Re: *An Application for a Certificate of Public Convenience and Necessity for the Benvoulin Substation Project No. 3698529*

REQUESTOR NAME: British Columbia Utilities Commission
INFORMATION REQUEST NO: 1
TO: FortisBC Inc.
DATE: October 15, 2008
PROJECT NO: 3698529
APPLICATION NAME: CPCN Application for the Benvoulin Substation Project

BCUC Diagram A2.2

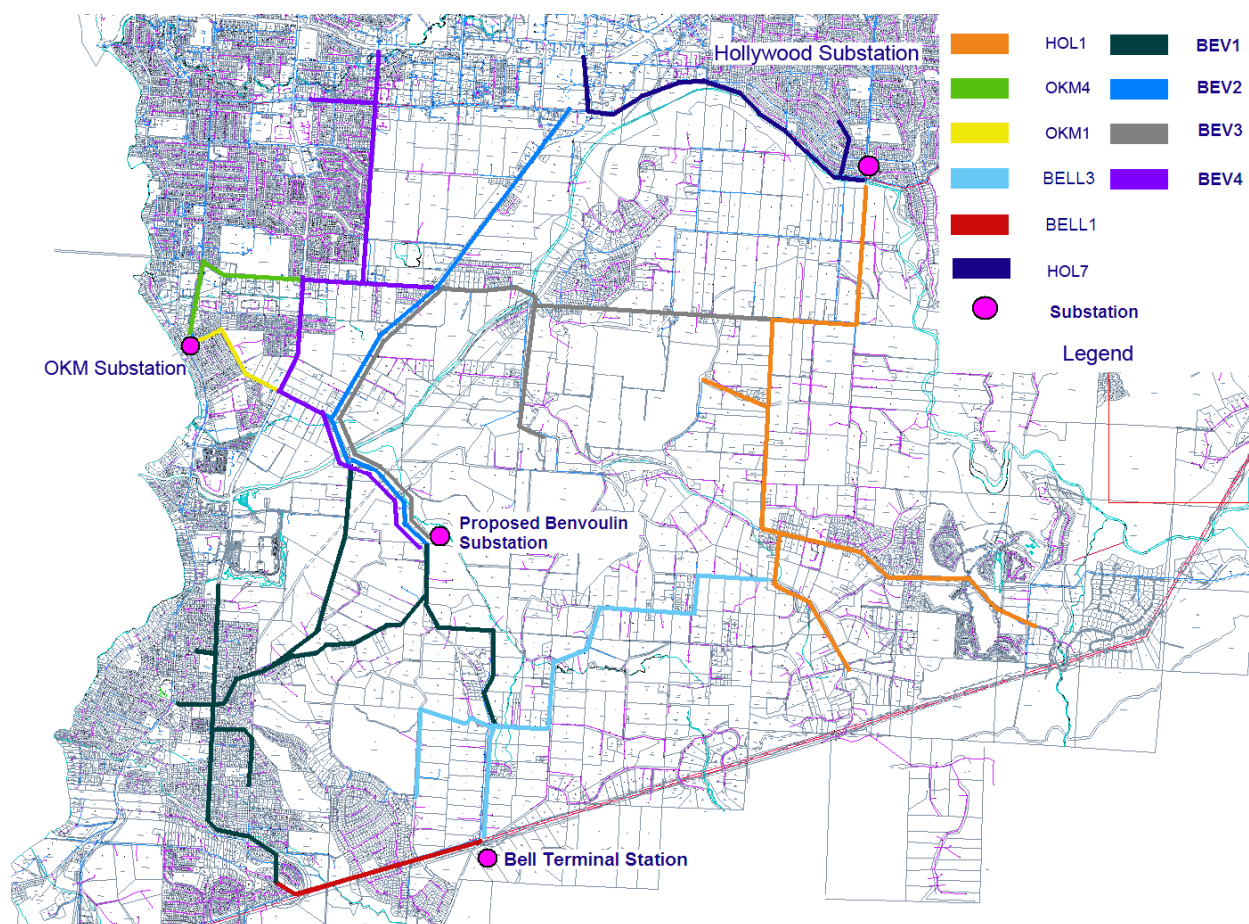
- 1 **Q2.2** Further to Diagrams 3.1, 4.1.1 and 4.1.2, please provide a diagram that
2 shows the proposed distribution circuits in the area, and which, by colour
3 coding or other means, identifies the substation supplying each feeder.
4 **A2.2** The information requested is found in BCUC Diagram A2.2 below.

EXHIBIT B-1, CHAPTER 3, SEC. 3.1, P. 11, DIAGRAM 3.1

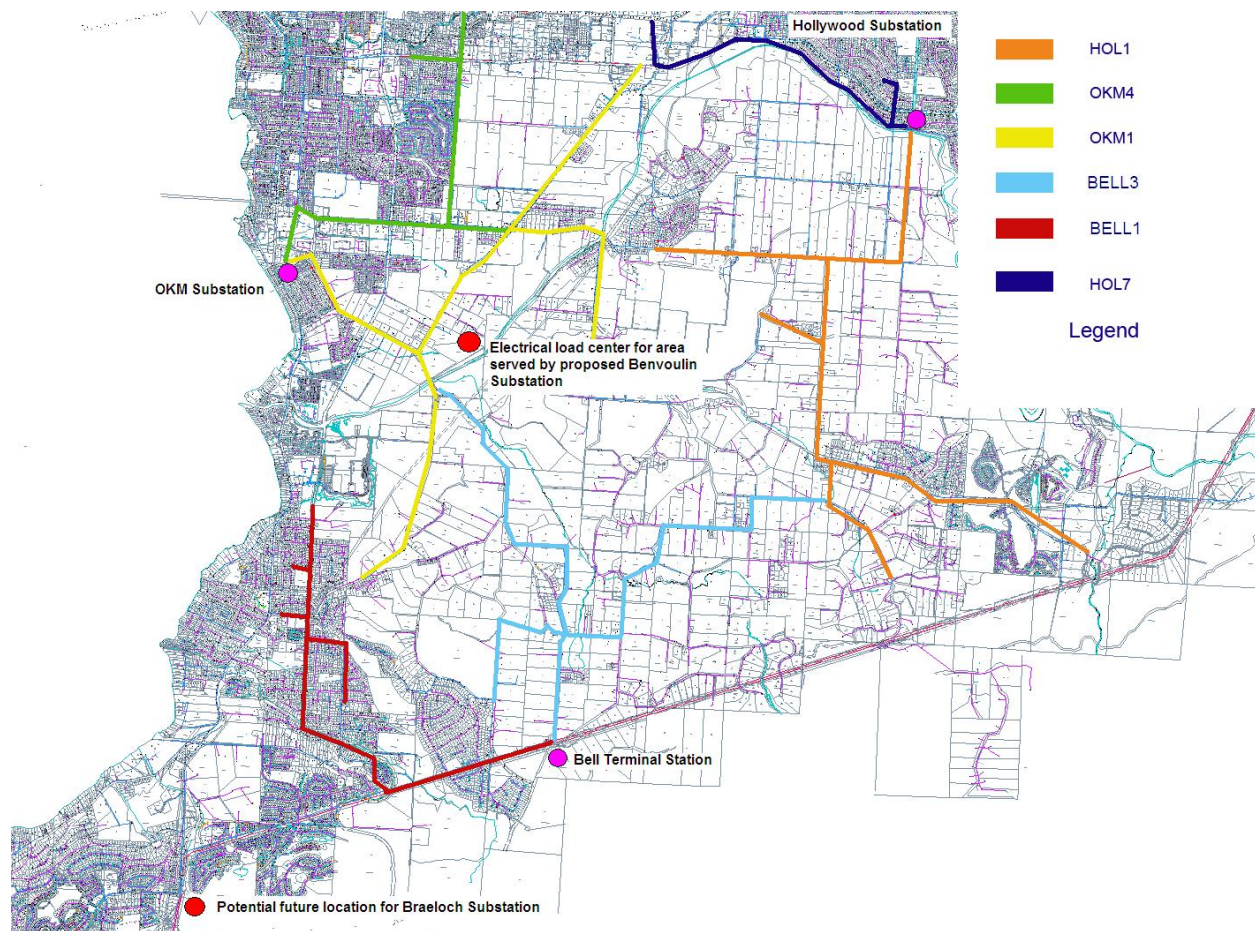
Q26.1 Please show a version of Diagram 3.1 with the following added:

26.1.1 Location of the existing area load centroid depicted.

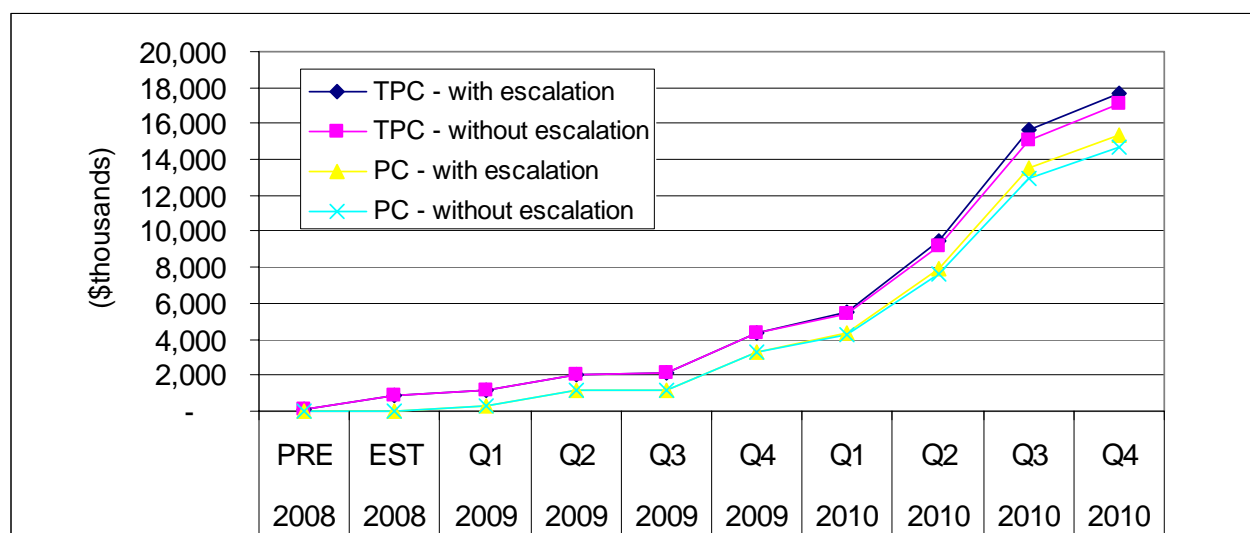
Q28.4 Please provide a graph of PMB and TPC showing the funding requirements by year in both constant year and escalated dollars.

A28.4 Please see BCUC Figure A28.4 below for the PC (project cost) and TCP (total project cost).

CONTROL BUILDING						DRAWING No.		REV.
DRAWN BY						317-GA(MOD)		0
CHECKED BY								
APPROVED BY								
6								
5								
4								
3								
2								
1								
REV	DATE	BY	CHECKED	DESCRIPTION	APP.	DATE

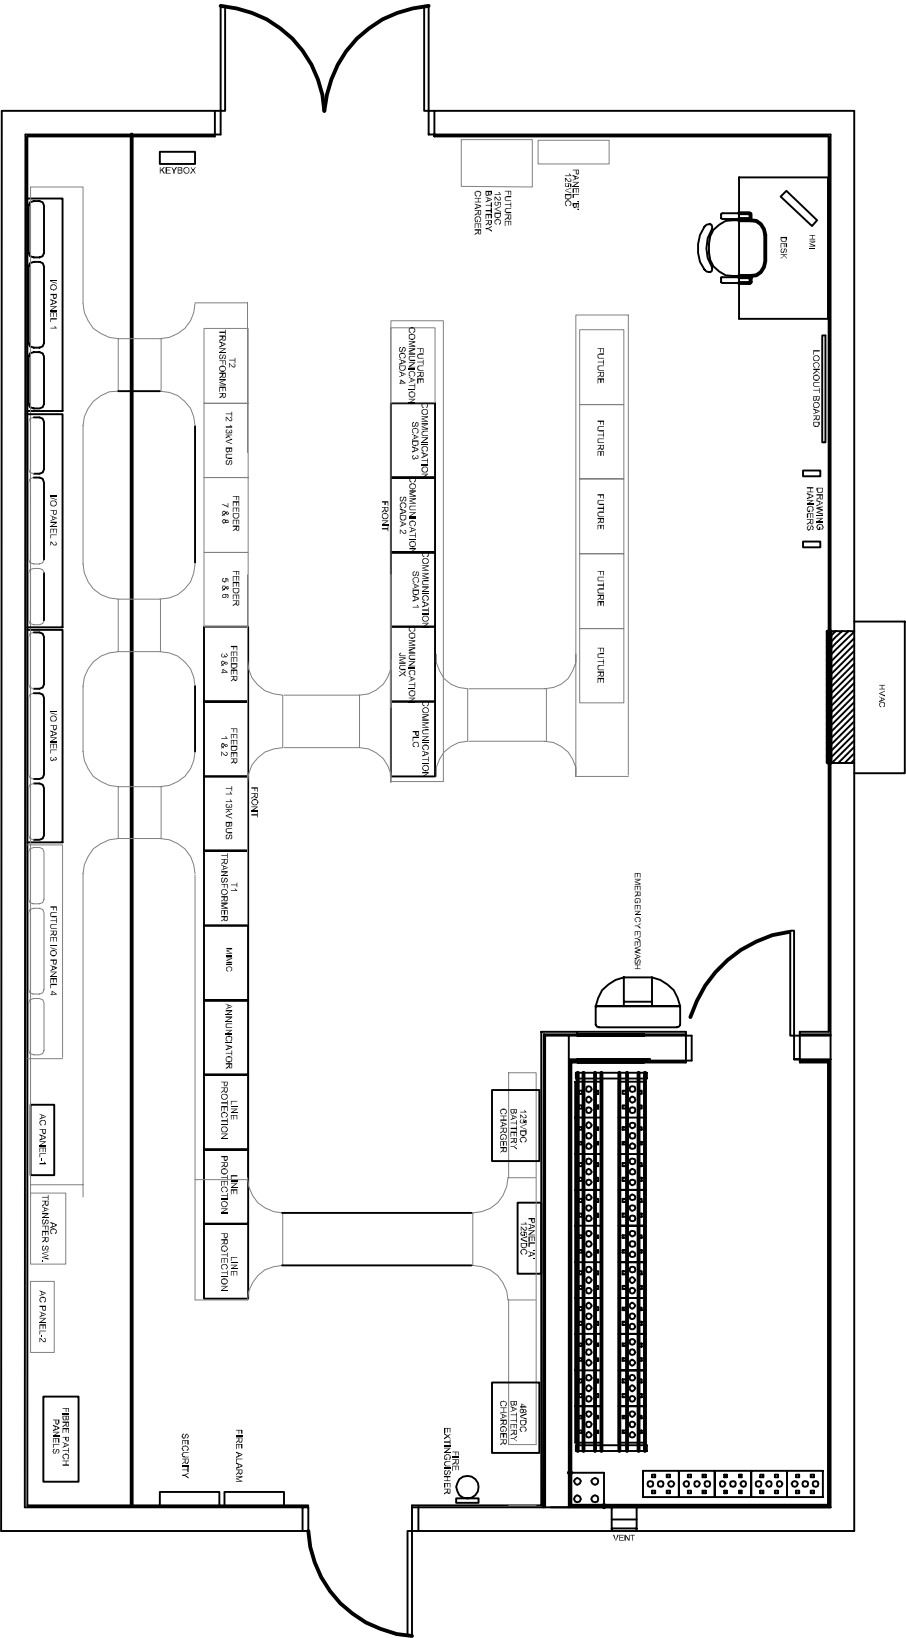
7 **Q33.5 Please provide a large scale drawing of the control building shown on**
8 **drawing 317-GA in appendix B including its future requirements.**
